Strathfield Independent Hearing and Assessment Panel (SIHAP)

Thursday, 6 April 2017

TO: Strathfield Independent Hearing and Assessment Panel – 6 April 2017
REPORT: SIHAP – Report No. 1
SUBJECT: 127 Cosgrove Road, Strathfield South - Part Lot 19 DP 1183316
DA NO: 2016/132

Figure 5: View of the eastern elevation noting the extent of the proposed building height variation.

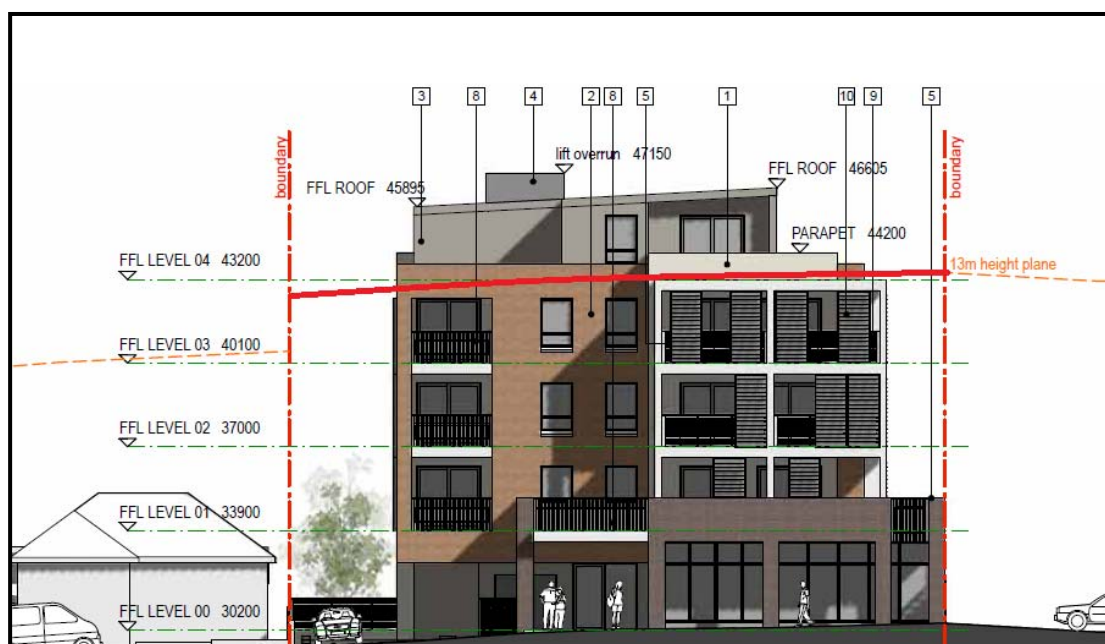
As demonstrated in the table above, the proposed development fails to comply with the maximum building height permitted under Clause 4.3 the SLEP 2012. The areas of non-compliance relate to the fifth storey containing a single two (2) bedroom unit and the lift overrun structure (refer Figure 5) that extends 3.95m above the maximum permissible building height of 13m resulting in a departure of 30.3%.

The applicant's written request to justify the contravention of the building height standard does not adequately address the matters required to be demonstrated in subclause 4.6(3), specifically, that compliance with the standard is unnecessary or unreasonable in the circumstances of the case, and that there are sufficient environmental planning grounds to justify contravening the development standard. The written request is not considered to provide sufficient substantive information on the environmental planning grounds relating to streetscape, bulk, scale and form, amenity, views, solar access and privacy.

Figure 4: View of the northern elevation noting the extent of the proposed building height variation.

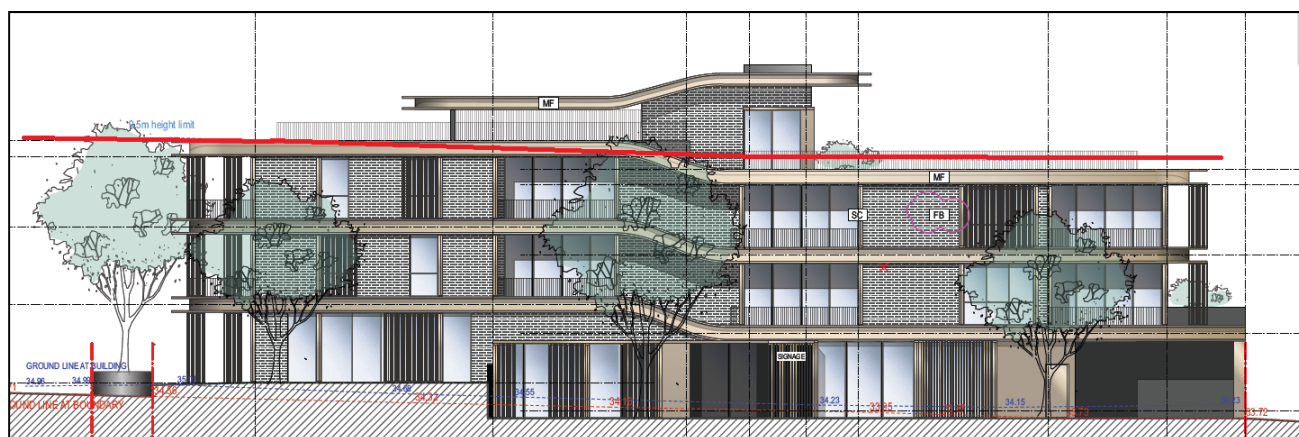
The proposed development fails to comply with the maximum building height permitted under Clause 4.3 of the SLEP 2012. The areas of non-compliance relate to the roof parapet, lift overrun and roof top pergola structure (refer Figure 4) that extends a maximum of 3.1m above the maximum permissible building height of 9.5m resulting in a departure of 32%. The proposed rooftop lift access, fire stairs and pergola structure attributing to the non-compliance departures provide improved residential amenity to the development and provide additional articulation to the structure.

Figure 1 – Elevational Shadow Diagram of 389-391 Liverpool Road at 9:00am 21 June (Winter Solstice).

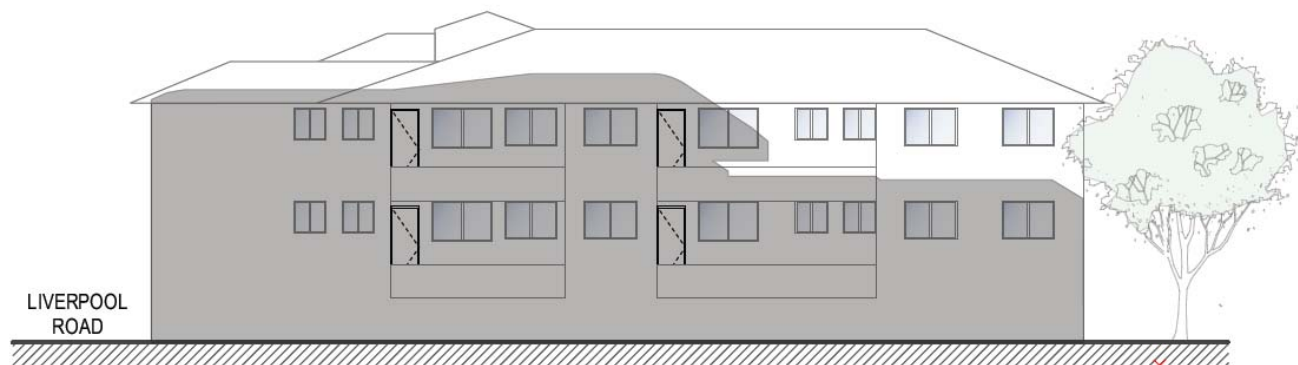
At 9am, the proposal casts a shadow to the south-west, overshadowing the majority of the northern elevation of the RFB at 389-391 Liverpool Road (refer Figure 1).

Figure 2 – Elevational Shadow Diagram of 389-391 Liverpool Road at 12:00pm 21 June (Winter Solstice).

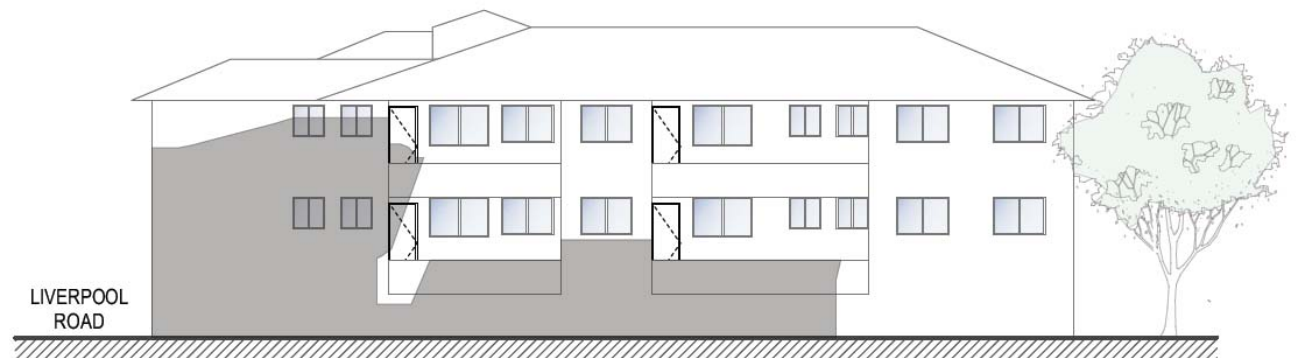
By 12 noon, the shadow has moved further east and affects the ground floor which contains non-habitable rooms including garages and laundry facilities and the eastern portion of levels 1 and 2 containing the toilets and master bedrooms of two (2) units (refer Figure 2). It should be noted that the master bedrooms of both units will retain solar access from windows on secondary elevations.

Figure 3: View of northern elevation noting the extent of the proposed building height variation.

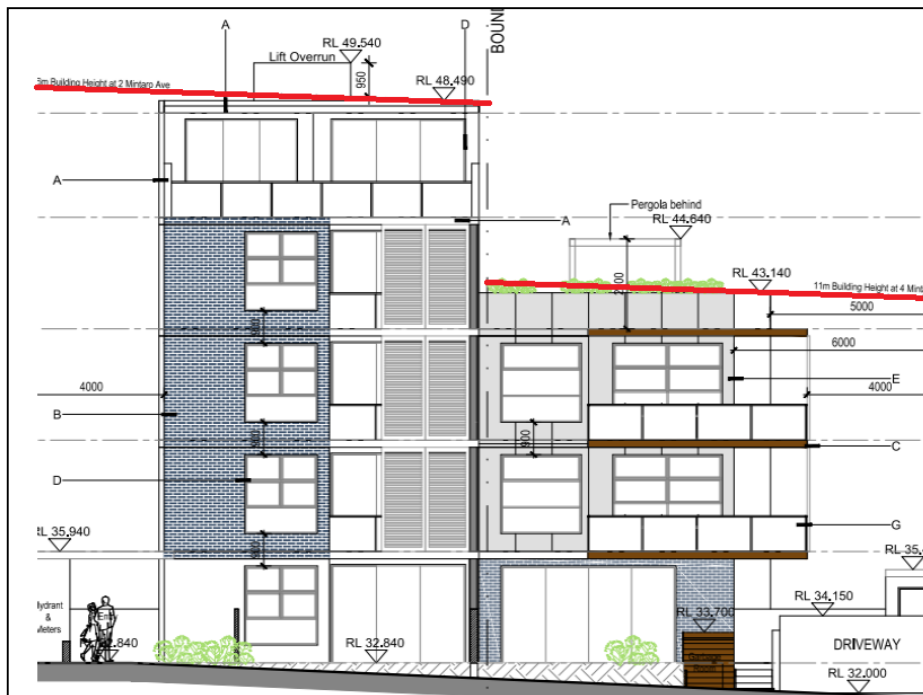
Under Clause 4.3 of the Strathfield Local Environmental Plan 2012, the maximum building height for the subject site is part 16m (2 Mintaro Ave) and part 11m (4 Mintaro Ave). While the proposed development incorporates a distinct step to achieve greater consistency with the maximum building height, the proposed development exceeds the maximum building height by 0.66m or 4% from the 16m height limit over 2 Mintaro Avenue and 0.83m or 7.5% from the 11m height limit over 4 Mintaro Avenue. These departures are attributable to the lift overrun structure and a pergola structure over the roof-top common open space area which provides improved residential amenity to the development (See Figure 1 below).

Figure 3: View of the northern elevation noting the extent of the proposed building height variation.

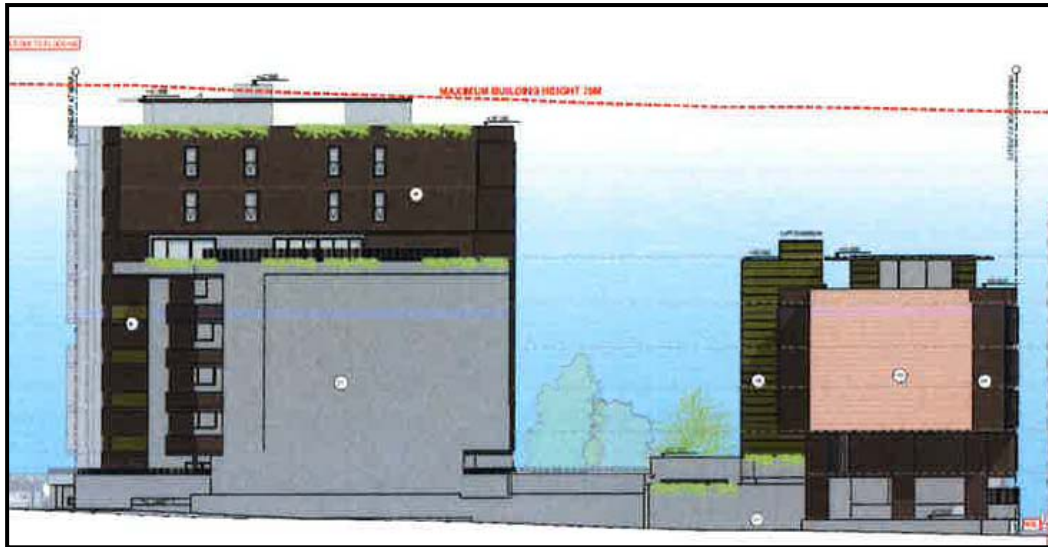
As demonstrated in the table above, the proposed development fails to comply with the maximum building height permitted under Clause 4.3 of the SLEP 2012. The

areas of non-compliance specifically relate to the lift overrun, (refer to Figure 5). As such, the proposed development extends 550mm above the maximum permissible building height of 29m resulting in a departure of 1.9%

Figure 4: Extract of the architectural plans showing the floor plan for levels 1 – 4

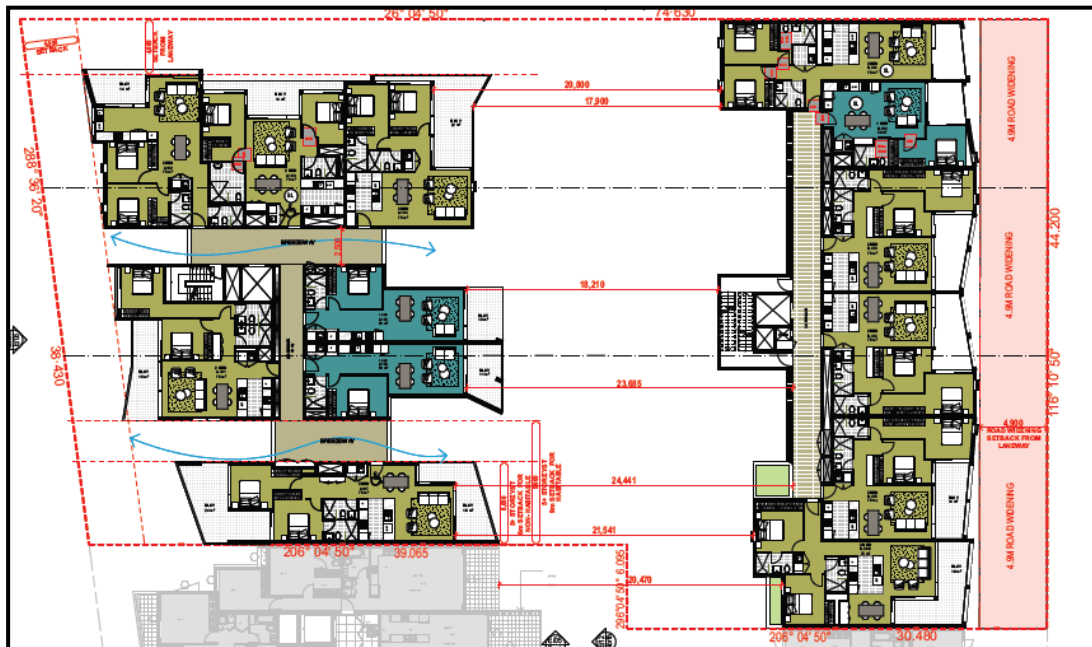
In accordance with 3F of the Apartment Design Guide (ADG) buildings up to a height of four (4) storeys are to provide a minimum 6m separation between habitable rooms and the nearest property boundary and a minimum 3m separation between non-habitable rooms and the property boundary. The proposed development has been designed as two (2) separate structures as per the illustration below extracted from the architectural plans:

Building B provides a nil side setback to both the northern and southern boundaries of the site and presents minimal opportunities for overlooking into adjoining properties with balconies orientated toward Loftus Lane providing passive surveillance to the street.

Figure 4: View of the eastern elevation noting the extent of the proposed building height variation.

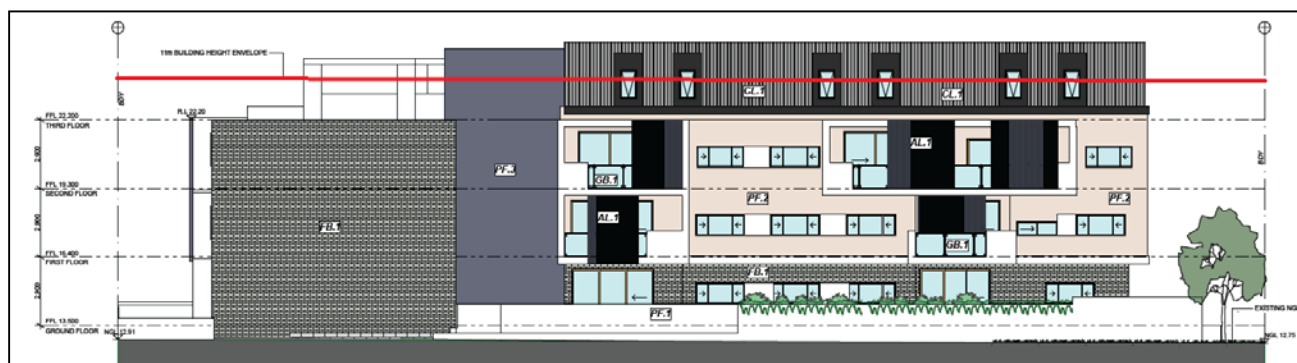
The proposed development fails to comply with the maximum building height permitted under Clause 4.3 of the SLEP 2012. The areas of non-compliance relate to a portion of the pitched roof structure and roof top pergola structure (refer Figure 4) that extends a maximum of 1.54m above the maximum permissible building height of 11m resulting in a departure of 14%. The proposed pitched roof structure assists in achieving greater compatibility with existing development in the streetscape, while the proposed pergola structure provides improved residential amenity to the development. Further, the area of compliance is setback from the buildings northern façade so as to minimise visual impacts.
